Minto Communities, LLC
Westlake Sales Center

Responses to Requests for Information

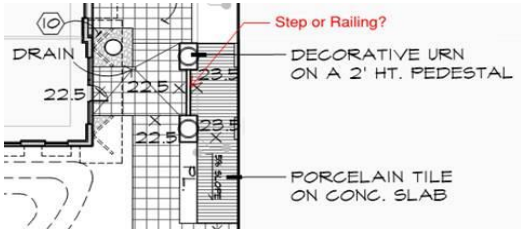
4.	<p>On the east side of the sales center there is a small porch/ramp. Between the two decorative urns these is a line depicted on the drawings that sits atop an elevation change of 12". Is this to be a railing of a step? See drawing below:</p> 	<p>It is a small 1' retaining wall with handrail.</p>
